Date: February 8, 1995
To: X3T10 Membership
From: John Lohmeyer
Subject: Minimum Negation Current Issue with Fast-20

6.1.2 Single-ended output characteristics

Figure 1 -- Active Negation Current vs. Voltage

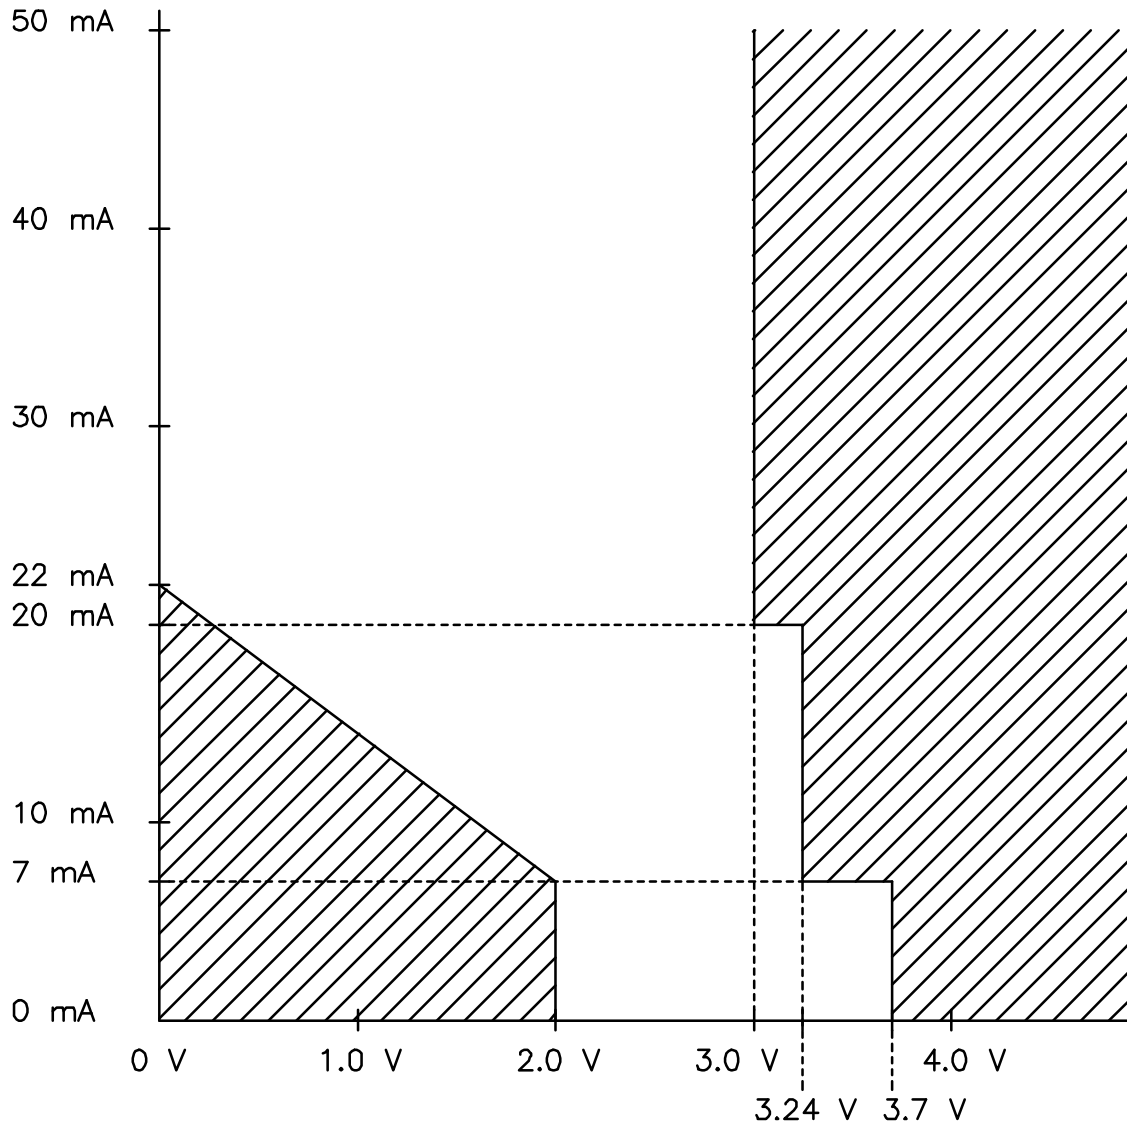
Revision 1 of this proposal changes the V-I plot in figure 1 to raise the minimum negation current at 2.0 volts to 7 mA from 0 mA. It also adds "d.c." to the last line of the first paragraph in 6.1.2 -- this is to clarify that the V-I plot does not apply to a.c. characteristics. The rest is unchanged.

After reading the SCSI Reflector messages on this topic and discussing the topic with our chip designers, I'd like to propose that section 6.1.2 be modified as shown in the document. It would replace items c), d), and e) from the output characteristics list with a new item c):

Figure 1 is new. It has the same characteristics for the old items c) and d) and reduces the drive requirements from the old item e) to a linear function going from points (0 V, 22 mA to 2 V, 0 mA).

"c) The output sourcing characteristics (signal negated) shall be constrained to operate in the non-shaded areas of figure 1."

Note: Figure 1 shows the allowed domains for the d.c. output characteristics of an active-negation driver when negated. It is not intended to show a.c. output characteristics, which may be different due to other requirements such as slew rate specifications. To measure the actual device d.c. output characteristics, it is necessary to vary the device load, so the test circuit shown in figure 2 is not applicable to this measurement.
